The Columbia Municipal Planning Commission will meet on Wednesday, March 12, 2025 at 4:00 PM in Council Chambers in the basement of City Hall, 700 N. Garden Street. The Planning Commission will consider the following:

RE: Project Name: Williamsport Landing, Phase 3, Final Plat
City of Columbia Staff Review Re-Submittal

Project #:	24-0418	Location:	Map 90 Parcels 7.12
Applicant:	Greg Gamble	Case Type(s):	Rezoning
Staff Planner:	Kevin C. McCarthy, AICP	Proposed Use:	Mixed-Use

REZONING
REQUEST
SHEET
L1.0

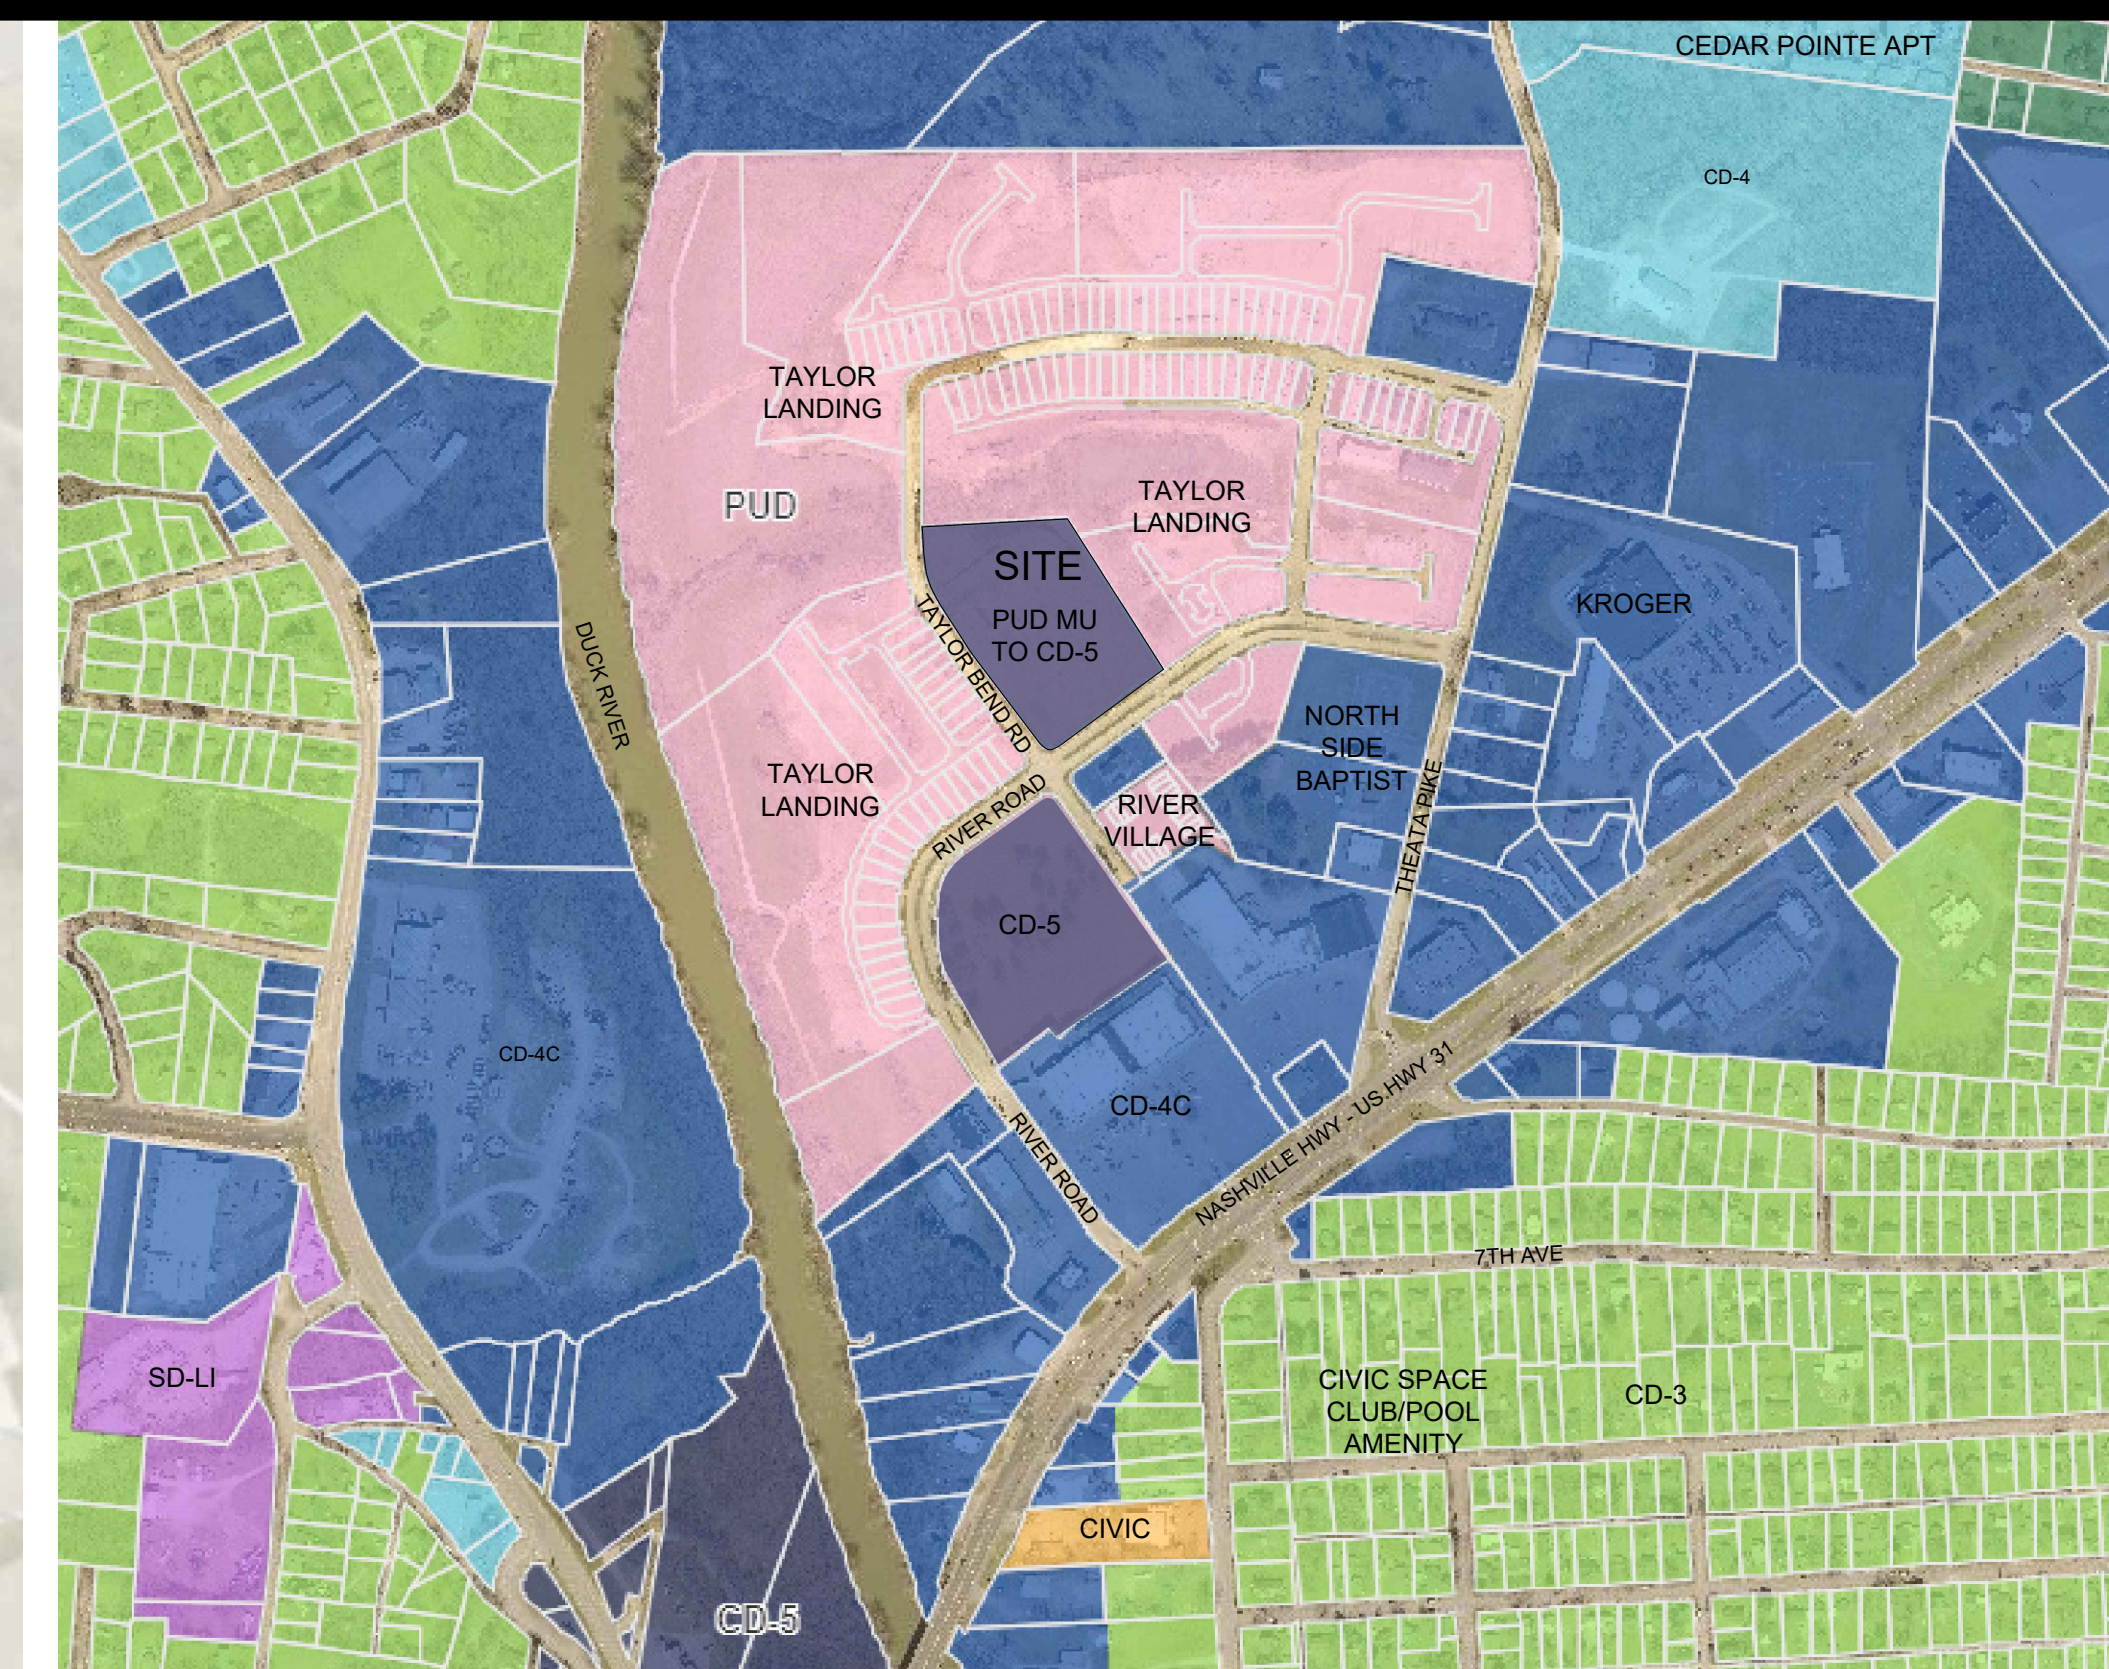
3. *Please add a note to the concept plan indicating that the subject site is less than 10 acres in size, does not include the creation of a new Thoroughfare or Internal Drive, and therefore is not a development parcel. Response: Please see Sheet L1.0. This note has been added.*

4. *The description of the rezoning request included on the concept plan explains the rationale. In the response to DRC comments, please provide additional information, if any, that will aid the CMPC's evaluation of the criteria at 8.5.19.H of the zoning ordinance. **Response: Please see the above response to this section of the zoning ordinance. Additionally, a narrative concerning the rezoning request is on the L1.0 Sheet.***
